Applicant's A.22(2A)(b) Response Statement to Louth County Council LRD025 Notice of LRD Opinion

Gort Mell Old Slane Road, Drogheda, Co.Louth

Prepared on behalf of
Lagan Homes Tullyallen Ltd

Figure 1 Extract from Waterman Moylan drawing SK02 provided under separate cover

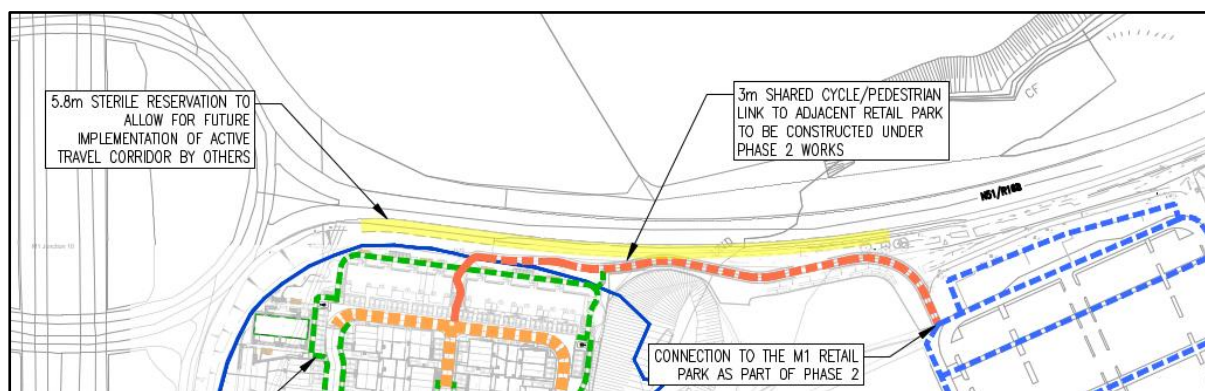
- ii. The provision of a continuous footpath/ cycle path along the northern boundary of the site (i.e. R168 south side only) towards the Hill of Rath Roundabout to tie in with a future Active Travel Scheme at this roundabout. The cost of this is to be borne by the applicant. This is required to support the retrospective provision of walking and cycling infrastructure in existing settlements, where feasible, to achieve growth in sustainable mobility and strengthen and improve the walking and cycling. The provision of the footpath(s) and cycle path(s) shall comply with the widths outlined in section 2.6 of "The Cycle Design Manual; footpath width 1.8m, cycle path width 3m (2-way) and buffer zone of 1m i.e. 5.8m. The new/ revised drawing(s) shall also clearly outline the provision of the correct tactile arrangement at all transitions and junctions.*

The subject LRD planning application seeks to amend a permitted SHD ABP-311768-21 (as modified under P.A.Ref. 2360368 and 240266) known as Gort Mell. As part of the parent permission a connection is provided from Gort Mell to the M1 Retail Park c.200m east of the development area. This connection provides access to the retail park, supermarkets and public bus services. The permitted link as illustrated by figure 1 consists of a 3m shared surface

As part of the Phase 2 modifications (P.A.Ref. 240266), a sterile section of land on the boundary adjacent to the R168 was provided to accommodate future provision of a footpath and cycle path. This sterile section of land achieves or exceeds the 5.8m requirement along the entire site boundary as illustrated by Waterman Moylan drawing no. OSR-WMC-ZZ-DF-DR-C-SK02 at Appendix A of the Response to Louth County Council LRD Opinion Report prepared by Waterman Moylan and submitted under separate cover.

The above request seeks to modify this link as part of the subject planning application and extend the route a further 200m to the Hill of Rath roundabout. These lands are outside the application site the subject of this planning application and are not in the control of the applicant. There is no Active Travel Scheme for the R168 including the Hill of Rath roundabout permitted at the time of this planning application.

It is submitted that the permitted link to the M1 Retail Park is the most appropriate and the extension of this footpath has no advantage to residents in terms of access to further services of community facilities. The desire line is to the retail park and this is provided for.
